# **CSOP**

## **MODEL EVALUATION AND RECOMMENDATIONS**

Revised on May 9, 2005

## Normalized Duration Curves for South End of WCA-3B

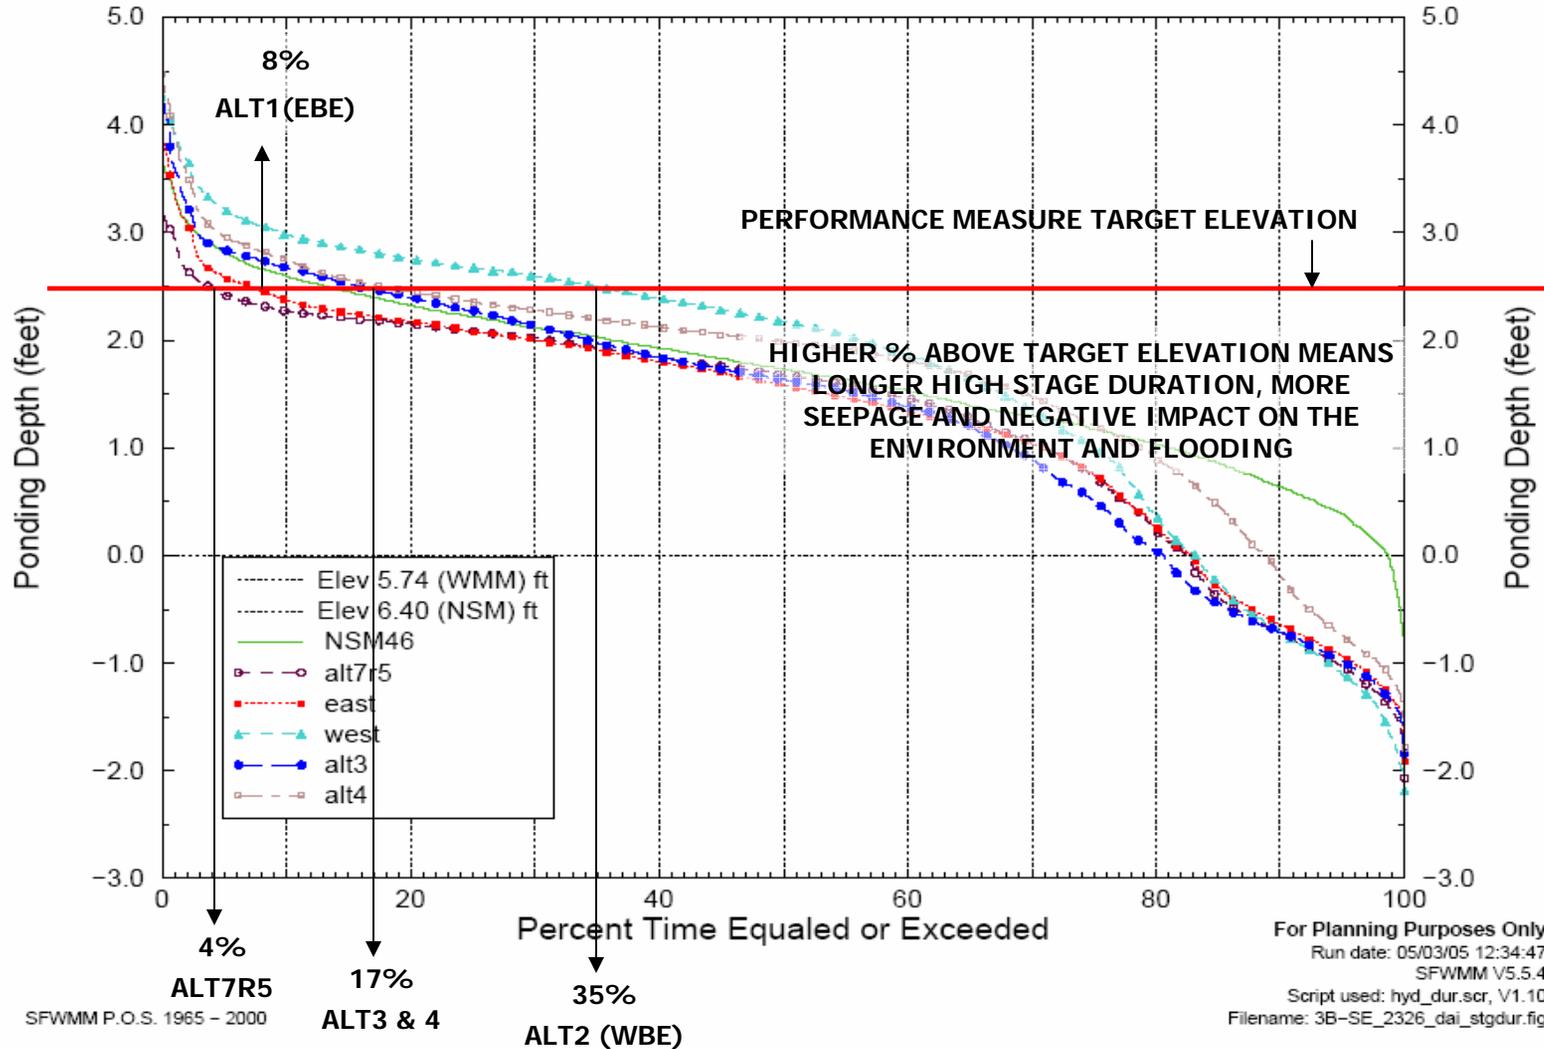
# STAGES ON WCA-3B – DEPTH 2.5 FEET

# RISE ON L-31N CANAL STAGES - ALTERNATIVE 4 – S-331

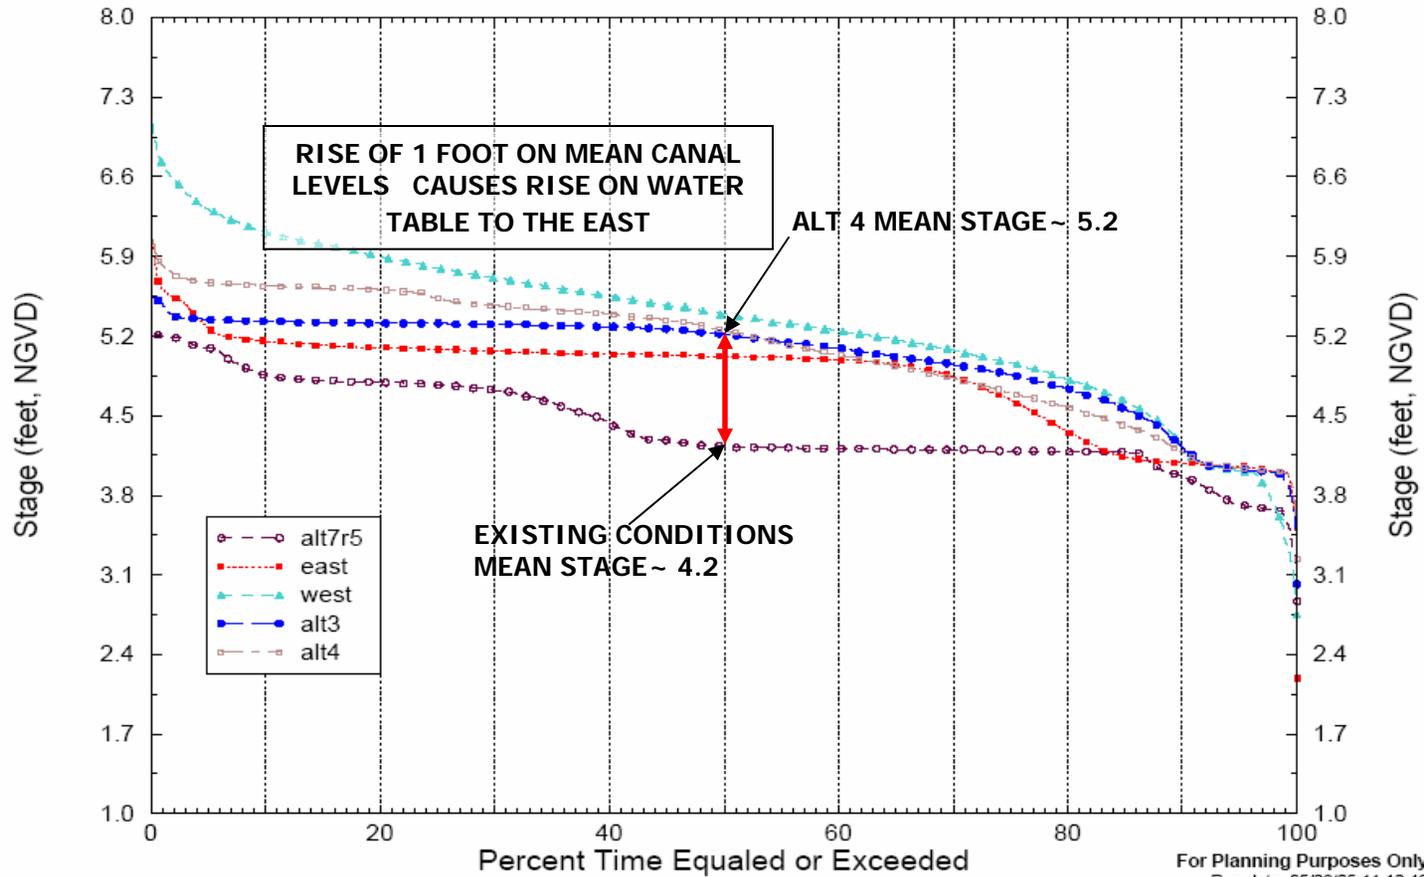
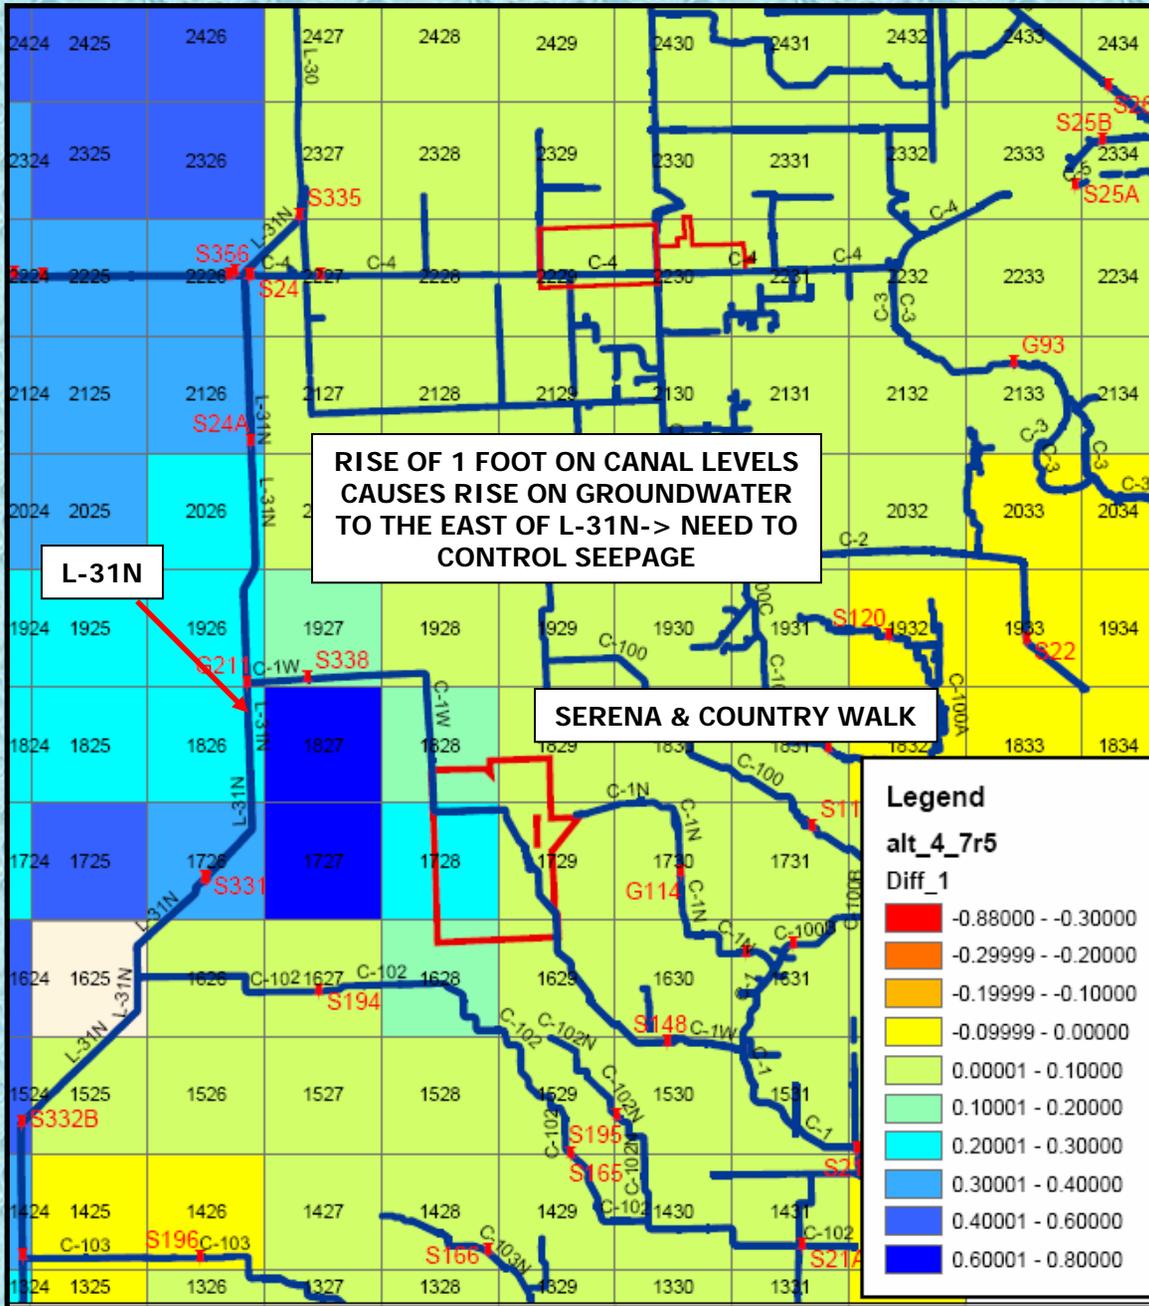
**SERENA AREA AND COUNTRY WALK 2X2 RESULTS WATER TABLE STAGE DIFFERENCE**

**ALTERNATIVE 4 – ALT 7R5**

**IN THE SERENA & COUNTRY WALK AREA, THERE IS A TENDENCY FOR INCREASE OF GROUNDWATER LEVELS WHEN COMPARED TO ALT7R5 (“EXISTING CONDITIONS”)**

**NOTE ON LEGEND:**  
POSITIVE NUMBERS MEAN INCREASE ON WATER LEVELS WHEN COMPARED TO MODELED EXISTING CONDITIONS (ALT7R5)
